VENDOR SERVICE PUBLICATION

SUBJECT: AVCO Lycoming Service Bulletin No. 469

Distributor Block Kit Part Number 10-682056 (6 Cylinder) Dual Magneto Series

To remove from service certain dual magneto distributor blocks.

Figure 1

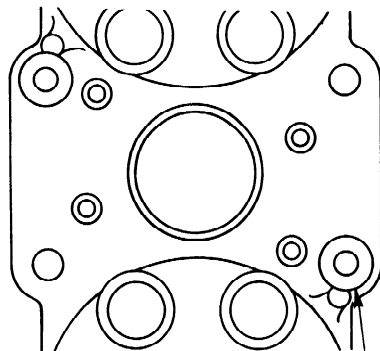
445 subject blocks were shipped from our facility. 296 shipped as spare blocks and 149 installed in magnetos. The reason for replacing these blocks is to increase the surface area on the block at the securing screw locations.

Reports indicate the flat washer P/N 10-4987 used on the distributor block securing screws P/N 10-35937-20 do not have sufficient diameter and may damage the block material when the screw is torqued.

To determine affected block, measure counter sunk hole to insure .427 inch diameter per figure 1. Reject block with counter sunk hole with .359 inch diameter only. All magnetos and spare blocks shipped from our facility, effective immediately, have a counter sunk hole with diameter .427 inch. See Figure 1.

Spare block kits shipped from the factory now include 4 flat washers, P/N 10-685548, as bag parts. The O.D. of the new washer is .396 inch. Original washer P/N 10-4987 with O.D. .328 inch should not be used with the block kit, P/N 10-682056.
